STAFF REPORT
KETCHUM PLANNING AND ZONING COMMISSION
REGULAR MEETING OF DECEMBER 9, 2019

PROJECT: 771 E 5th Street (Bierbaum) Accessory Building

APPLICATION TYPE: Mountain Overlay Design Review

FILE NUMBER: P19-123

L102

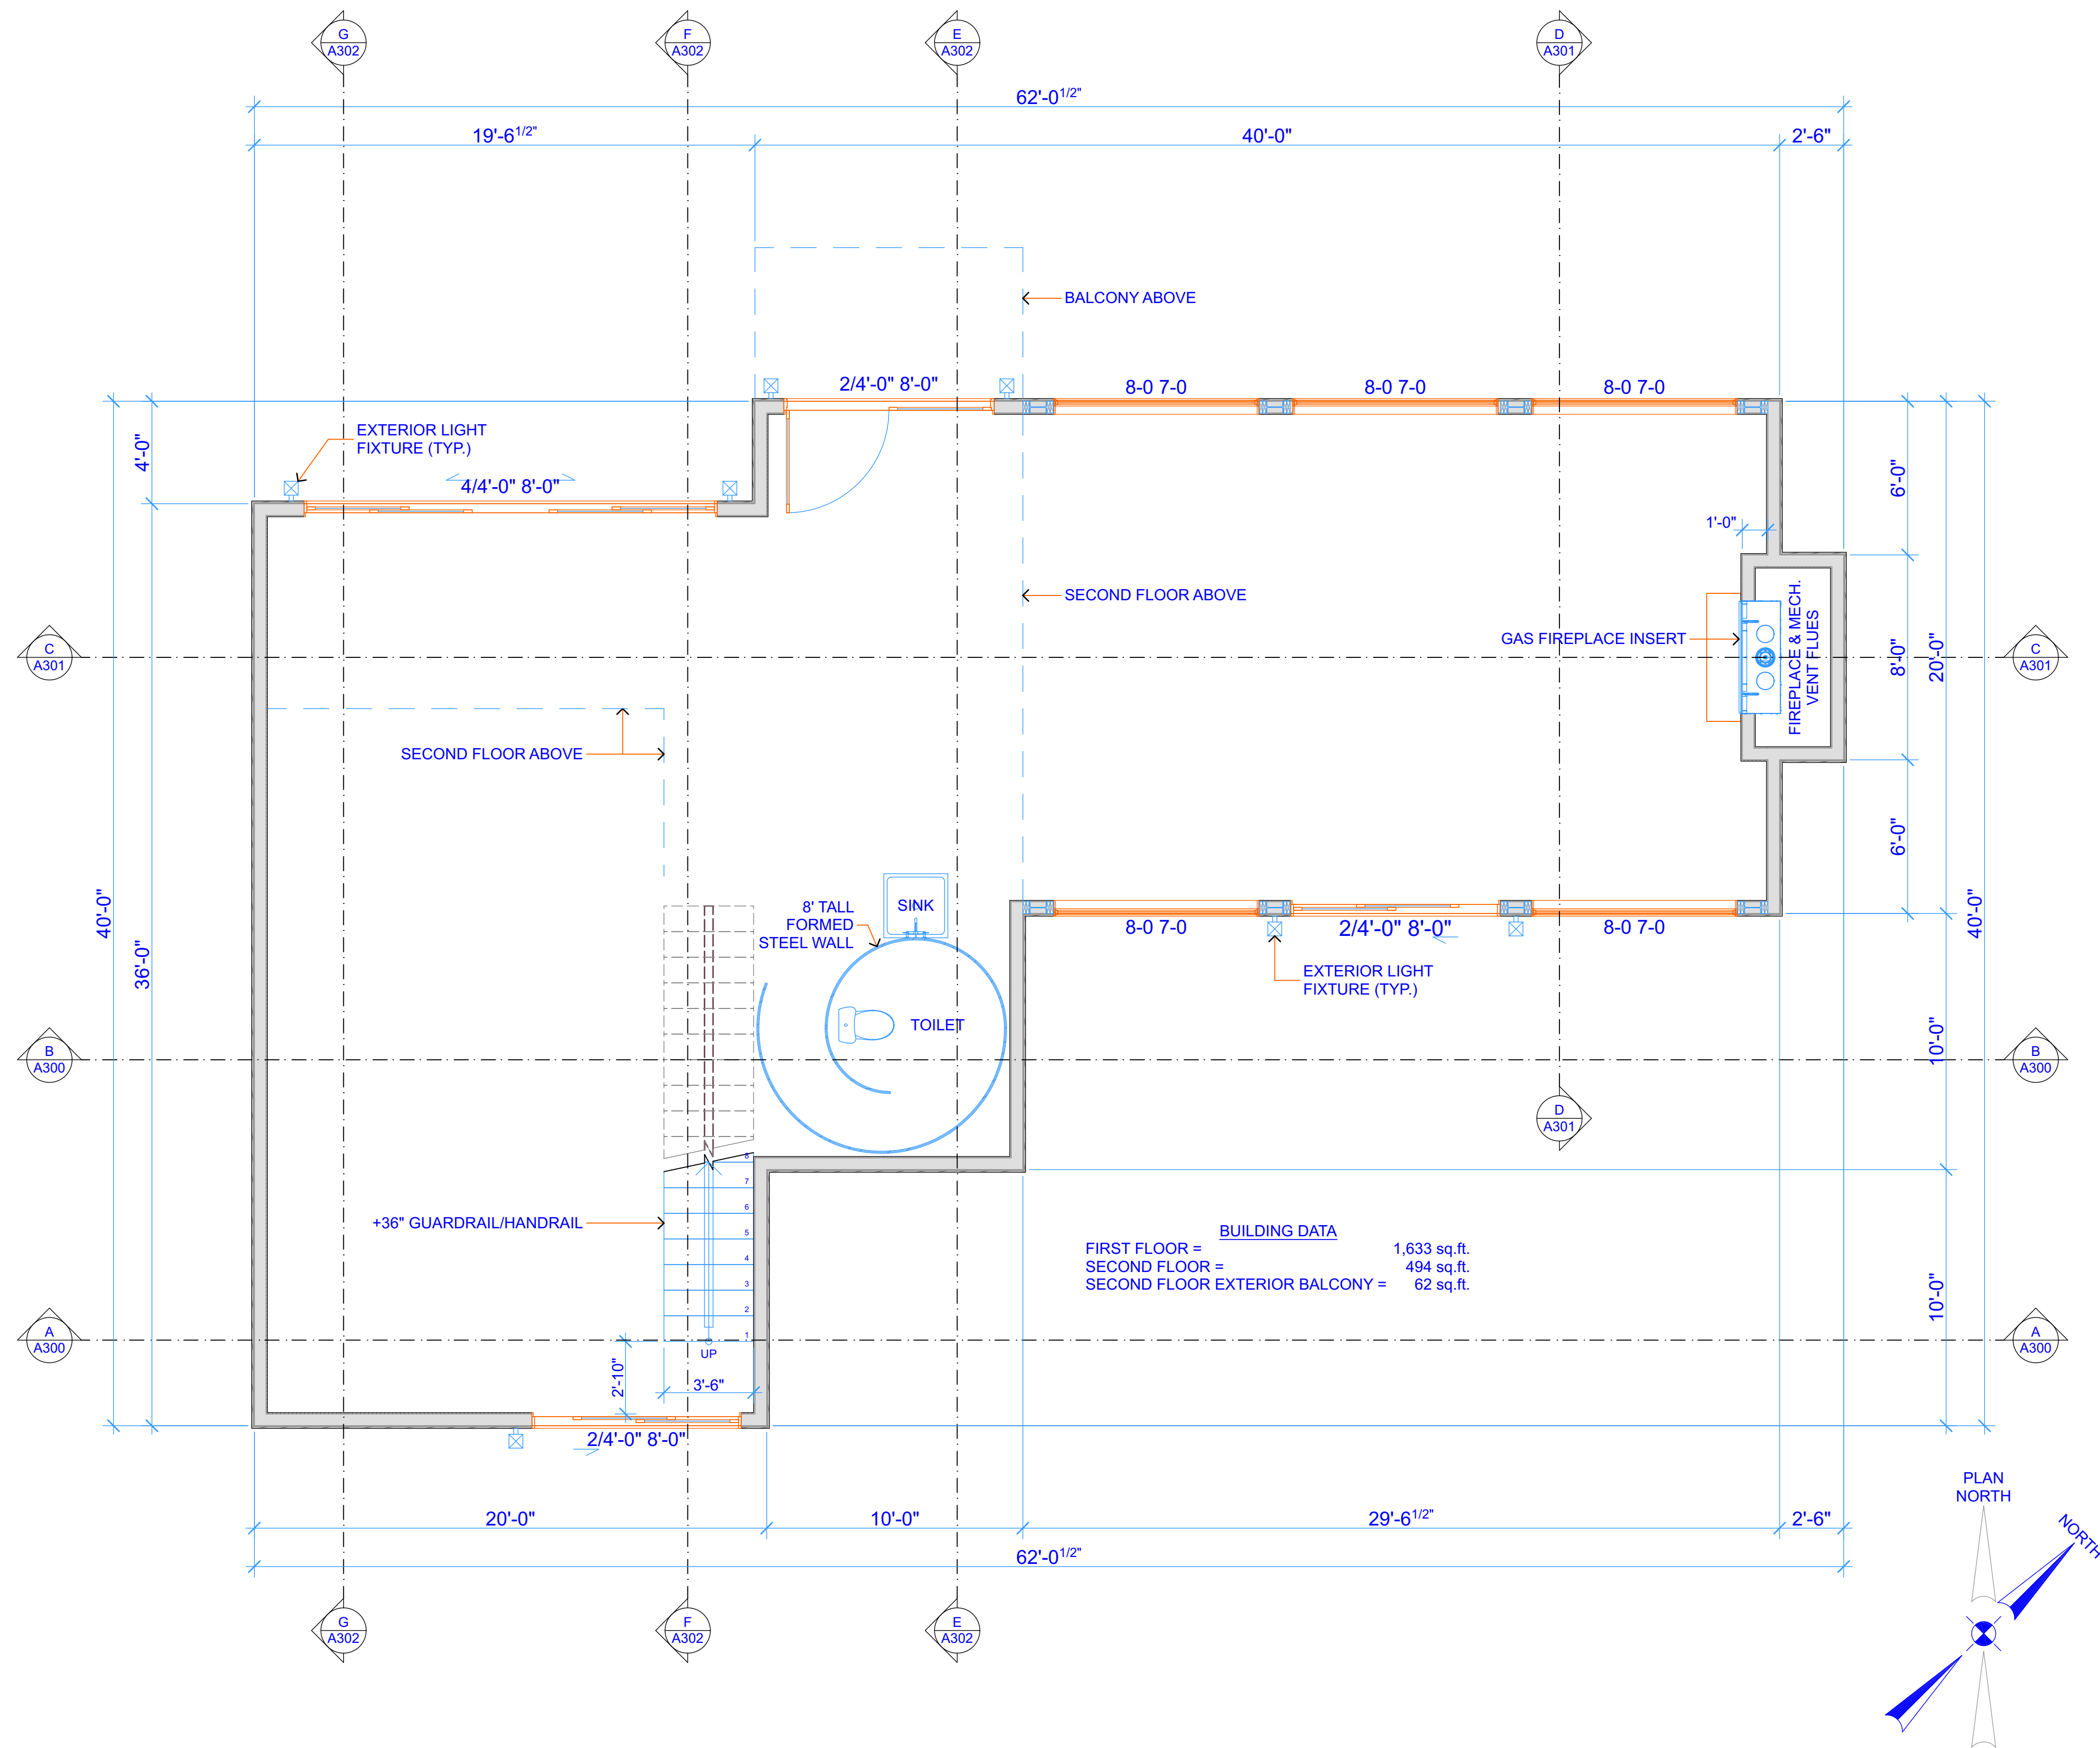
<i>Staff Comments</i>	<i>As indicated on Sheet L102, the applicant has proposed two snow storage areas—407 sq ft and 498 sq ft—that encroach within the private driveway and utility easement. As conditioned, the proposed snow storage areas are subject to approval by all easement beneficiaries and shall not restrict driveway access to a width narrower than 20 ft. If the driveway easement becomes too narrow for emergency vehicle access or impairs lines-of-sight, then the snow storage must be accommodated elsewhere on subject Lot 4A or hauled off-site. City of Ketchum Ordinance No. 1146 prohibits the storage of snow or ice from private properties within public rights-of-way.</i>
<input checked="" type="checkbox"/>	<input type="checkbox"/>	<input type="checkbox"/>	17.96.060(H)(2)	Snow storage areas shall be provided on-site.
			<i>Staff Comments</i>	<i>The applicant has proposed two snow storage areas that encroach within the private driveway and utility easement that bisects subject Lot 4A. As conditioned, the proposed snow storage areas are subject to approval by all easement beneficiaries and shall not restrict driveway access to a width narrower than 20 ft. If the driveway easement becomes too narrow for emergency vehicle access or impairs lines-of-sight, then the snow storage must be accommodated elsewhere on subject Lot 4A or hauled off-site. City of Ketchum Ordinance No. 1146 prohibits the storage of snow or ice from private properties within public rights-of-way.</i>

2. The proposed snow storage areas as indicated on Sheet L102 of the MO Design Review submittal drawings are subject to approval by all beneficiaries of the private driveway and public utility easement and shall not restrict driveway access to a width narrower than 20 ft. If the driveway easement becomes too narrow for emergency vehicle access or impairs lines-of-sight, then the snow storage must be accommodated elsewhere on subject Lot 4A or hauled off-site.

A300

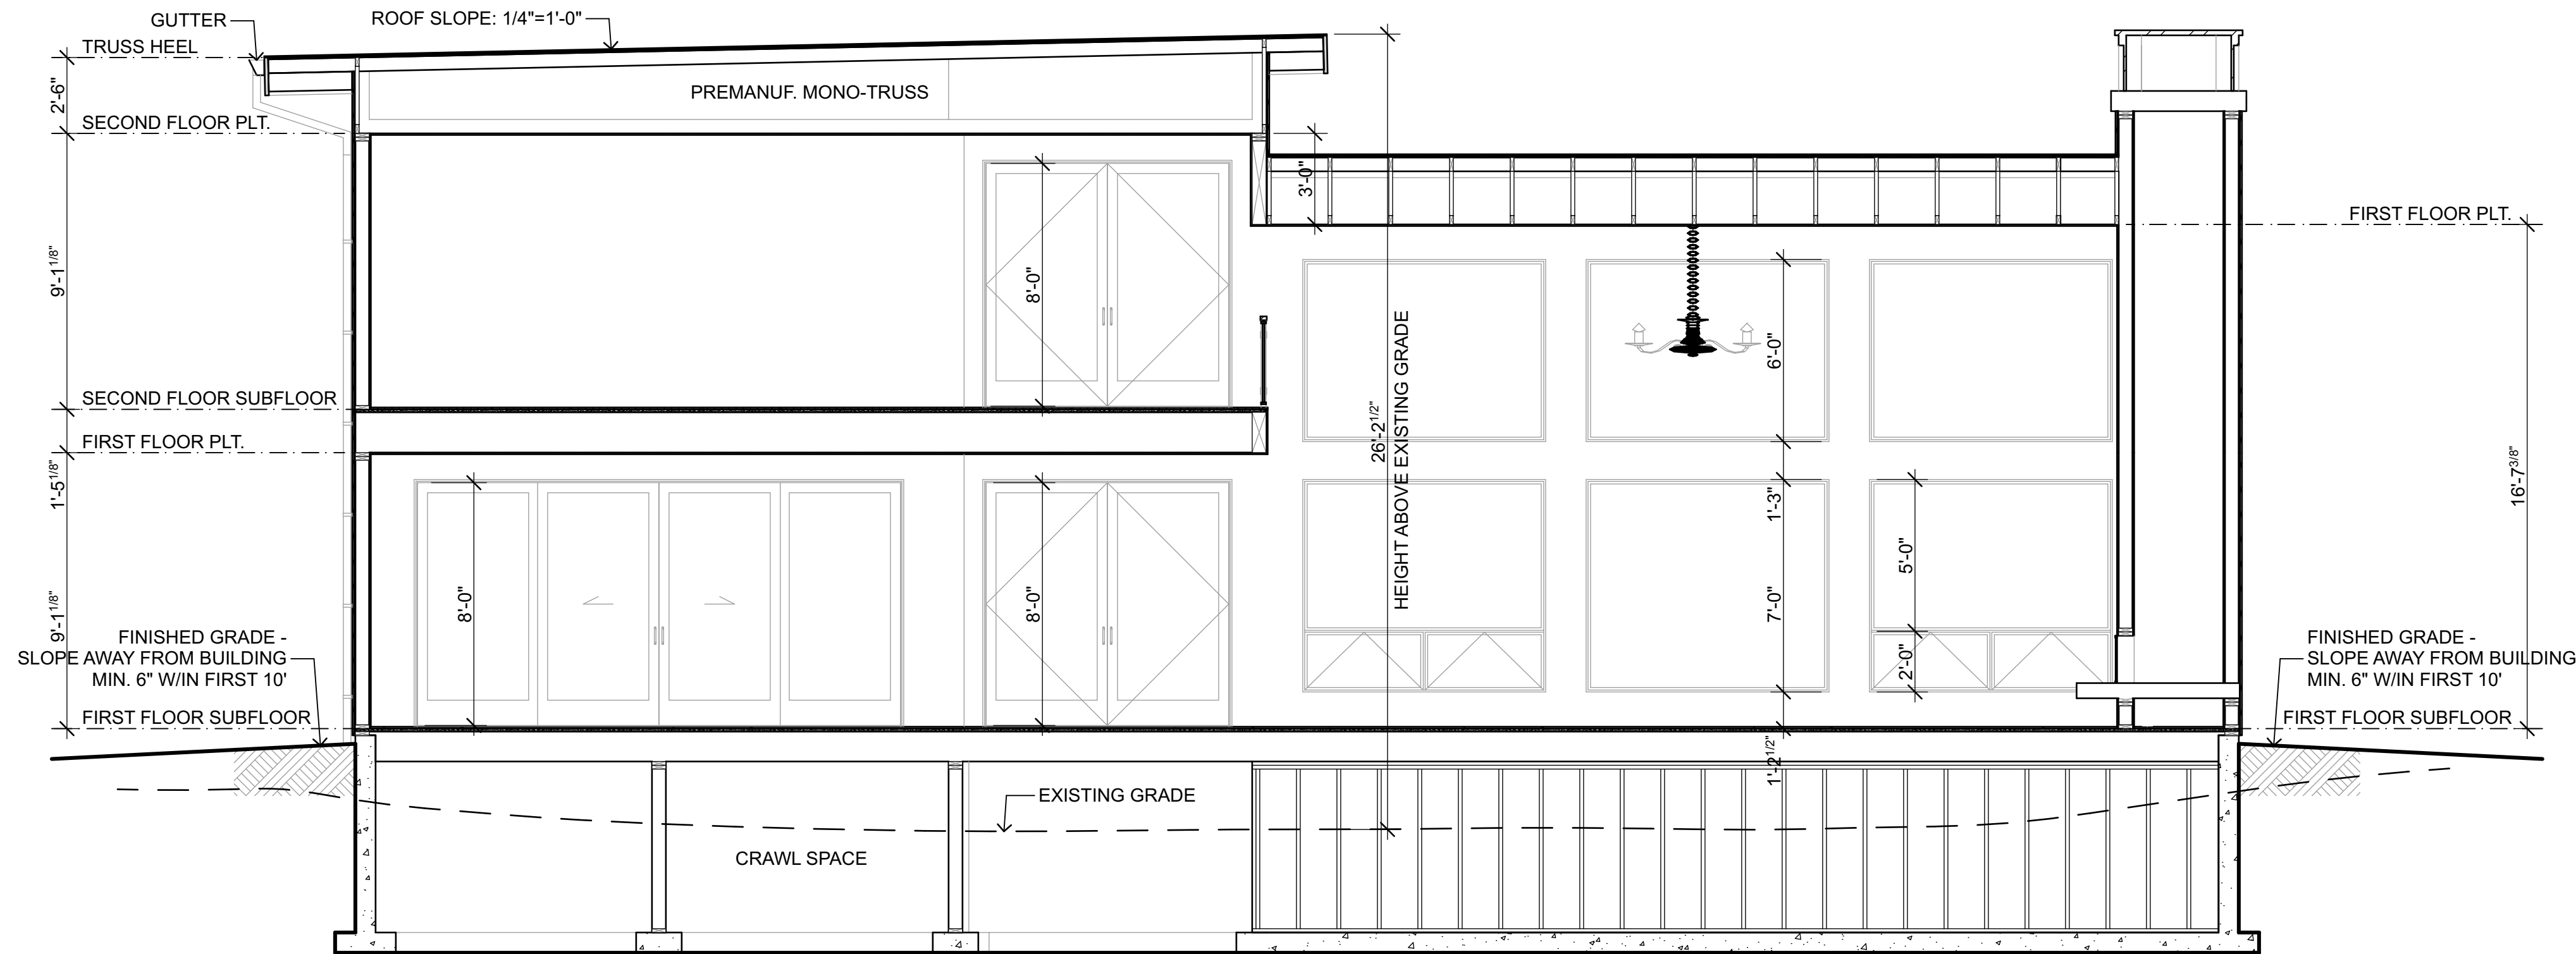
<input checked="" type="checkbox"/>	<input type="checkbox"/>	<input type="checkbox"/>	17.12.030 Staff Comment	<p>Building Coverage</p> <p>Permitted: 10% LR Zone: 35% AF Zone: 10%</p> <p>Existing: Single-Family Residence on Former Lot 4 (LR Zone): 10% (1,949 sq ft building coverage/20,000 sq ft lot area)</p> <p>Proposed: Accessory Building on Former Parcel BB (AF Zone): 6% (1,695 sq ft building coverage/29,195 sq ft lot area)</p> <p>Total Single-Family Residence (LR Zone) & Accessory Building (AF Zone): 8% (3,644 sq ft building coverage/49,195 sq ft lot area)</p>
<input checked="" type="checkbox"/>	<input type="checkbox"/>	<input type="checkbox"/>	17.12.030 Staff Comment	<p>Minimum Building Setbacks</p> <p>Minimum Required Setbacks (AF Zone): Front: 25' Side: 25' Rear: 25'</p> <p>Proposed Accessory Building: Side (W): 25'-2" Side (S): 27'-6"</p>
<input checked="" type="checkbox"/>	<input type="checkbox"/>	<input type="checkbox"/>	17.12.030 Staff Comment	<p>Building Height</p> <p>Maximum Permitted (AF Zone): 35' Proposed Accessory Building : 29' from existing grade (Sheet A300)</p>
